Report to Planning and Environment Committee

Subject: 2126983 Ontario Inc. (Darryl Neville)
1806 Avalon Street
City File: Z-8283, Ward 2
Public Participation Meeting

Date: June 11, 2024

Concept Site Plan

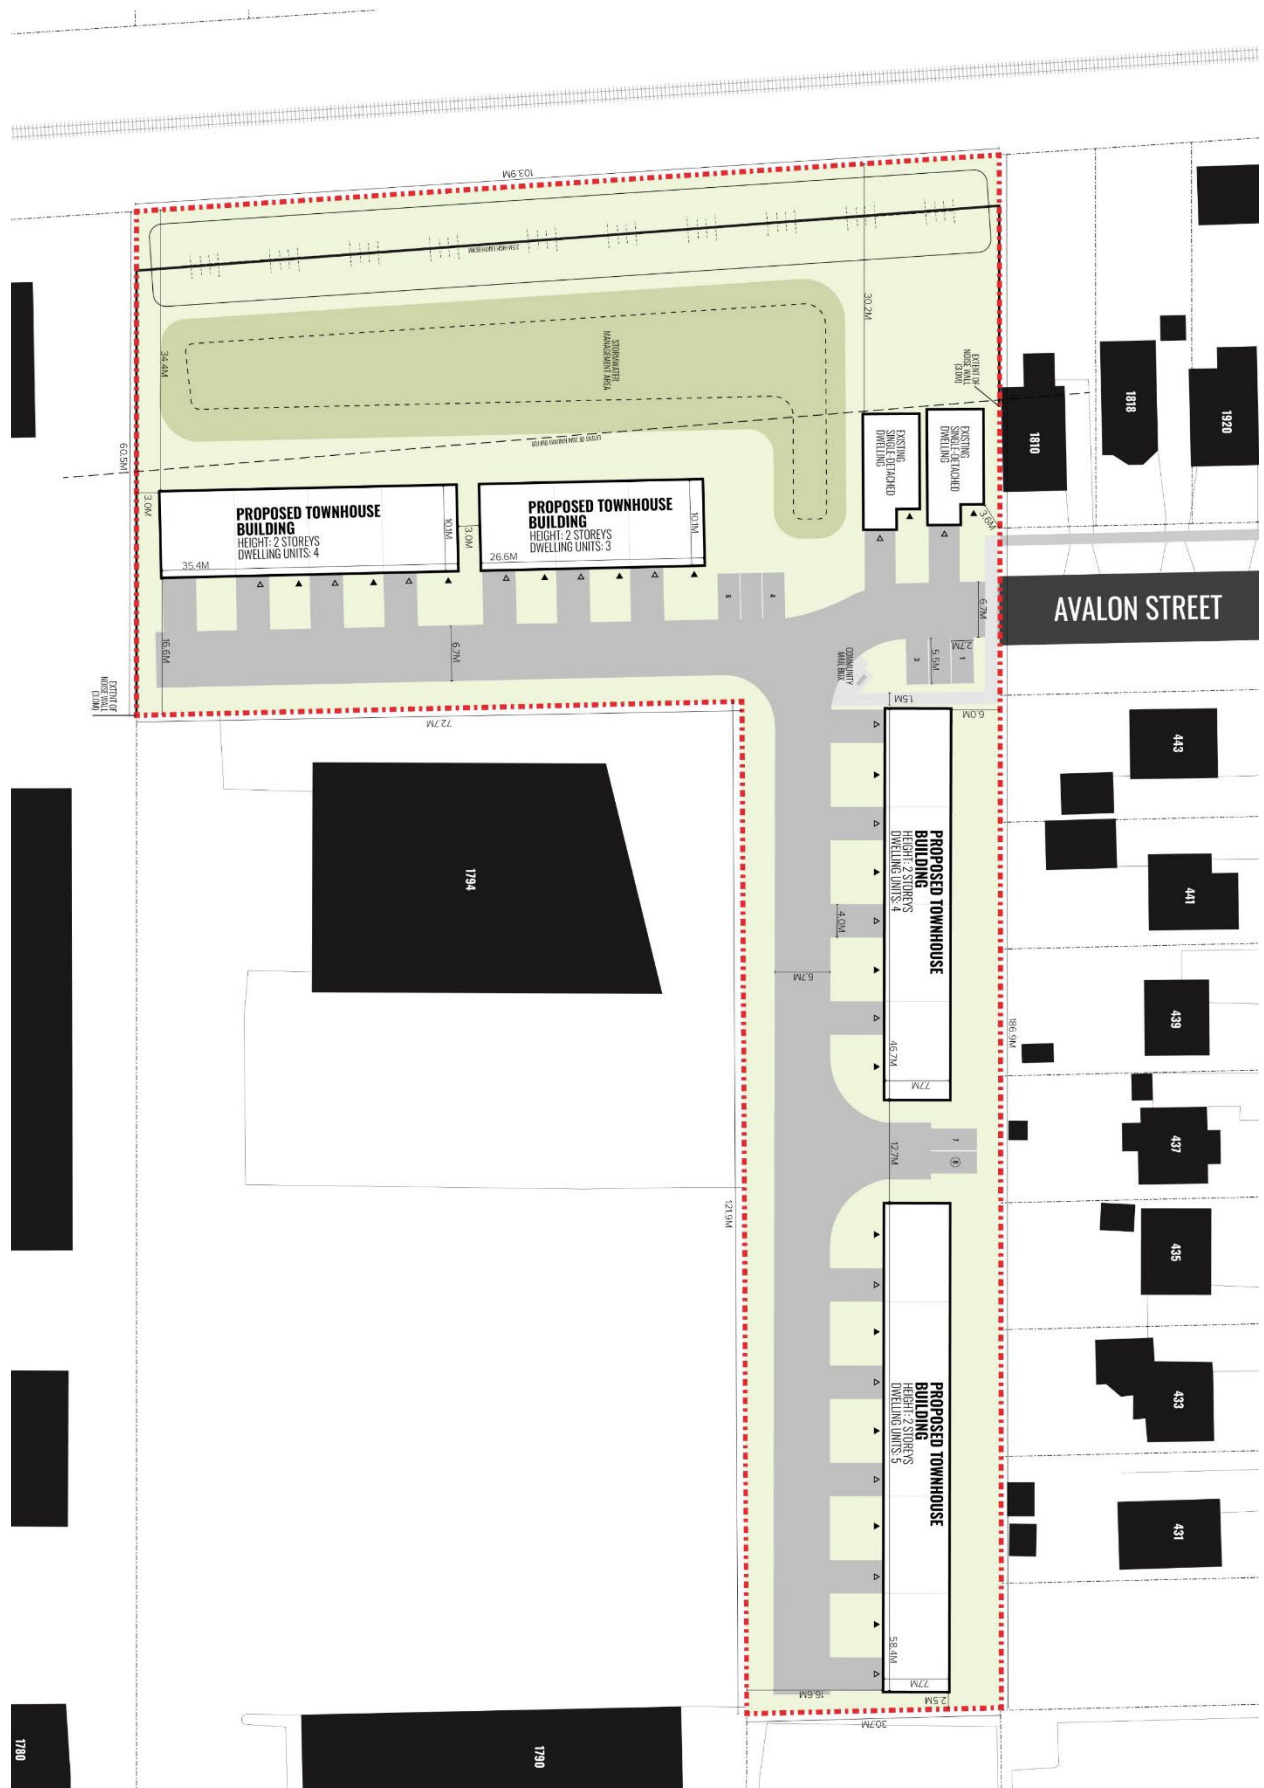
- Remove visitor parking stalls 7 and 8 to provide a greater separation buffer between the south property boundary and the proposed townhouse dwelling. Alternatively, this space can be utilized for a common amenity. Based on a total of 18 units, only 2 visitor parking stalls are required.

- Provide internal pedestrian connections through the site
- Identify the location of any rear yard decks to confirm compliance with the Zoning By-law or to determine if a special provision is required.
- A special provision is required for the setback from the property line to the existing single detached dwelling (front yard setback of 2.0 metres).
- The current site design does not provide for adequate amenity space for the number of units on site given the limited setbacks to the property boundaries and stormwater management pond.

- Reduce the driveway widths to 3 metres to provide more landscaping
- If there are any substantial changes, please recirculate for comment.
